Subject: AP1000 COL Standard Technical Report Submittal of APP-GW-GLN-106, Revision 1 (TR 106)

1. APP-GW-GLN-106, Revision 1, "Mechanical System and Component Design Updates," Technical Report Number 106

APP-GW-GLN-106
Revision 1

Figure 1 CRDM Cooling Air Flow Path in IHP

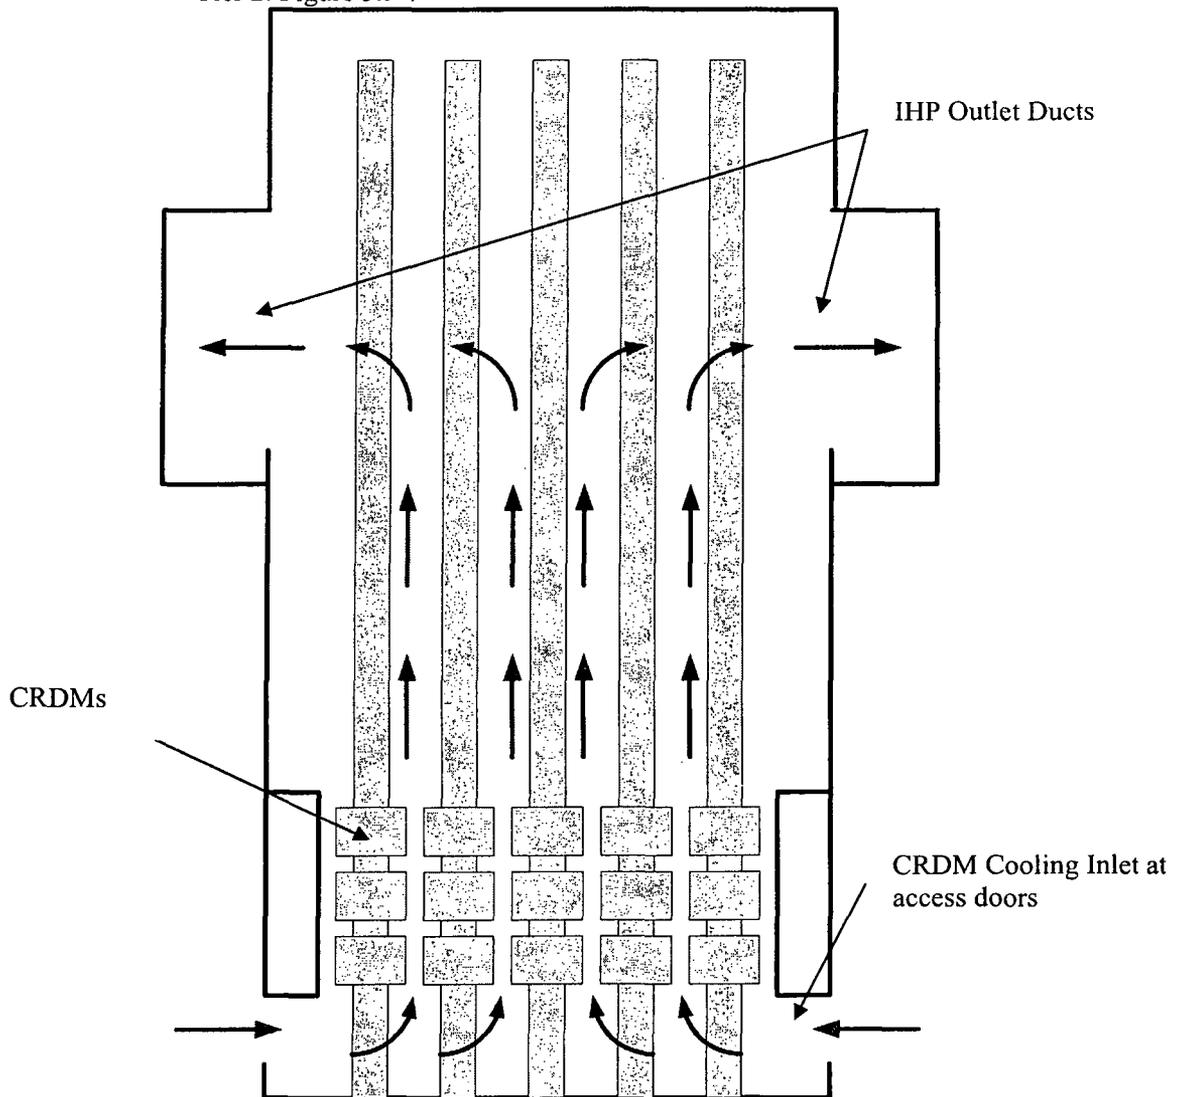
2.d Design Change 185, IHP Design:

One of the functions of the Integrated Head Package is to provide cooling to the CRDMs. A design change has been made to the CRDM cooling system to reduce the system pressure drop and CRDM air flow exit temperature. This has been achieved by removing the internal baffles that caused a high pressure drop. The CRDM airflow now is sucked in through the CRDM inspection doors, past the CRDMs and exits near the top of the IHP shroud. The airflow path is shown in the Figure 1 below. Figure 1 below supersedes the figure originally provided as part of the response to RAI TR61-01. TR 61 is Westinghouse document APP-GW-GLN-014, Revision 0 "AP1000 Integrated Head Package."

The IHP design change has resulted in updates to the following subsections of the DCD:

- Tier 2: Figure 3.9-7

FIG. NOG-5416.1-1 TYPICAL SINGLE-HOIST DRIVE UNIT

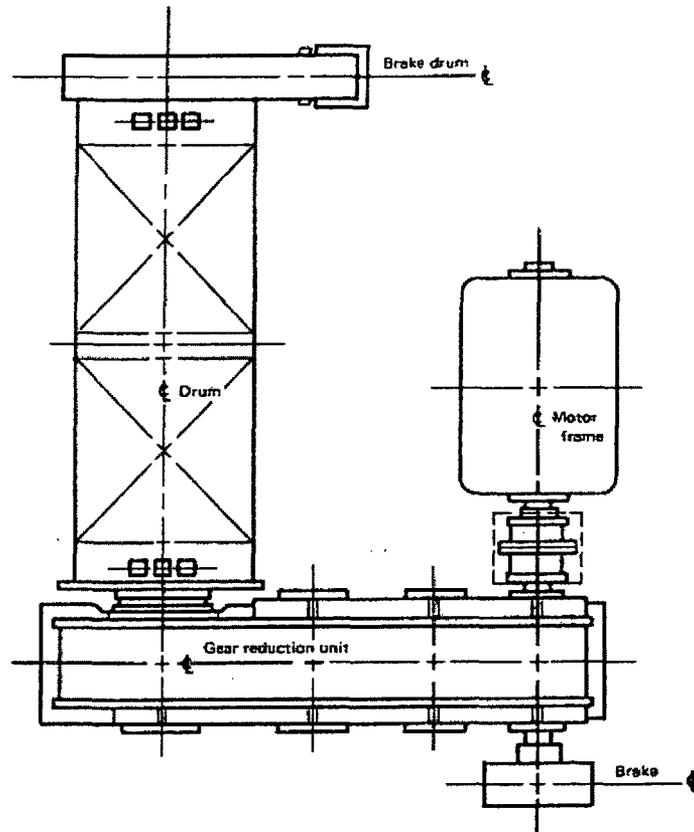
- b. Therefore DCD Sections 9.1.5.2.1.3 and 9.1.5.2.2.3 have been changed.
 - c. NOG-1 paragraph 5121(b) addresses a “single hoist drive unit” as a holding brake and paragraph 6417(d) addresses “a control braking means using dynamic braking or line regeneration.” As well, NOG-1 Figure 5416.1-1 shows a hoist drive configuration that includes a single motor, single reducer, single holding brake, and a brake on the drum. NOG-1 Figure 5416.1-1 is attached below.
